RE: Villa Jardin/Coral Gables (IR20-144)

WALKSacramento reviewed the project routing for Villa Jardin/Coral Gables (IR20-144), and we appreciate the opportunity to offer comments.

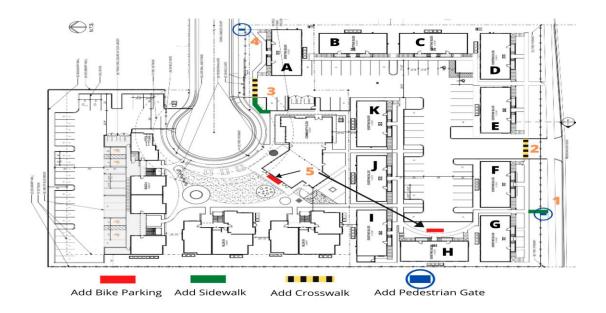
It is important to note that the site plans do not provide clear markers for identifying individual buildings. Therefore, I provided a visual of the site plan for recommendations with letters designating the existing buildings. The project site is within census tract 4203, where 63.9% of residents engage in physical activity or exercise outside of their work. The project's addition of a community center and upgrading the recreational area as part of the new development will support this area's active members. The current pedestrian circulation system shows that Existing Buildings A, B, and C along the eastern edge of the property line lack adequate connections to the proposed common spaces, which will make it difficult for some people to access them safely. Putting a crosswalk and sidewalk connecting Building A to the community center and trash enclosures will allow for a safe and useful route for residents to access these open spaces. Buildings B and C have no direct and safe path for individuals with mobility disabilities to be able to access the new amenities safely. More time should be spent improving the connectivity from Buildings B and C to the common spaces being developed.

The entire Villa Jardin/Coral Gables project will be fenced and have gated entrances for pedestrian and vehicle access. The site plan indicates that two new pedestrian gates would be placed at the end of the cul de sac. Yet, the pedestrian access along Meadowview Road between Building D and E has no gate, and the site plan shows a door but does not note that a new gate will be present. Similarly, there is no pedestrian gate near the sidewalk of Building A to Coral Gables Court, and no proposal of a gate is made. With 8.8% of the census tract

population commuting to work via transit, walking, or biking, safe and secure access to the project site must be afforded. Since there is a sufficient amount of commuting, accessibility should also be considered. Buildings F and G have no immediate connection to Meadowview Road. Currently, residents have to cross the driveway, which has no crosswalk markings to proceed to the existing pedestrian exit between Buildings D and E. Limiting the number of entry points makes it harder for residents to access transit stop or light rail station in the neighborhood.

Lastly, the site plan does not indicate or show where bicycle parking will be placed for cyclists. Installing bike parking would not only meet the requirements set by the City, but also provide a space for people to lock their bikes instead of securing them to trees or poles that could block the existing walking paths. Placing them along the community center's west entrance would fulfill the requirement and provide close and direct access to the surrounding units.

- 1. Add a sidewalk and pedestrian gate between Building (F&G) to Meadowview Road. This will provide pedestrians connections to Meadowview Road, transit stops, and the Pannell Meadowview Community Center.*

- 2. Add a crosswalk on the driveway between building E&F giving a connection to existing pedestrian gate exit to Meadowview Road and safe route to the community center and recreation area within the development.*

- 3. Add a crosswalk and sidewalk connecting residents from Building A to the Community Building and trash enclosure. Will provide a safe route for residents to access these amenities.*

- 4. Add a pedestrian gate near the sidewalk of Building A to Coral Gable Court. Provides safe entry point and access to Coral Gable Court.*
- 5. Add bike parking along the west entrance of the community center and in front of **Building H**, limiting the number of bikes being locked to trees and poles.*
